**From:** Eric Thornsbury  
**To:** Lois, Erasmia; Yerokun, Jimi  
**Date:** 12/20/05 6:56AM  
**Subject:** HRA Comments

TO: Eric Thornsby, ACRS Staff Engineer  
FROM: George Apostolakis, ACRS Member  
RE: Focus of Human Reliability Analysis

1. At the December 16, 2005 meeting of the ACRS subcommittees on human factors and reliability & probabilistic risk assessment, I suggested that the focus of Human Reliability Analysis (HRA) models should be the time the operators take to perform a given task. This memorandum summarizes my thoughts on this matter.

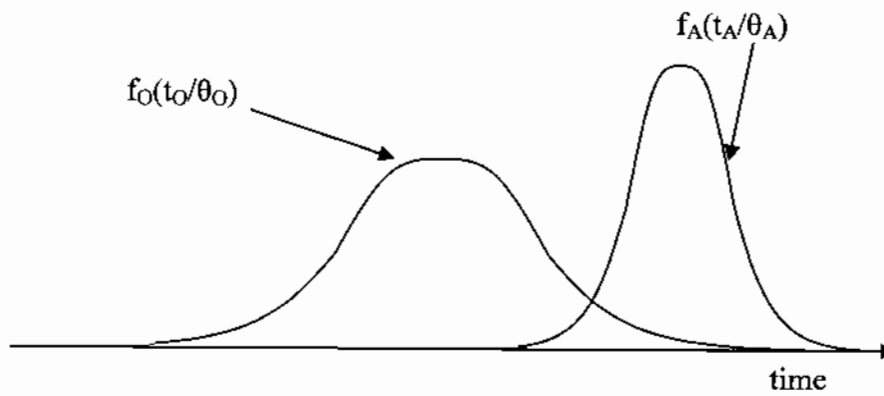
g. To better understand eq. (2), we look at the following picture:

- h. This picture shows the aleatory curves only. The double integral in the brackets of eq. (2) is the probability that  $T_O > T_A$ . To get the complete picture, imagine that each of the above curves is a member of a family of curves that are indexed according to the epistemic distributions  $\pi_O(\theta_O)$  and  $\pi_A(\theta_A)$ .
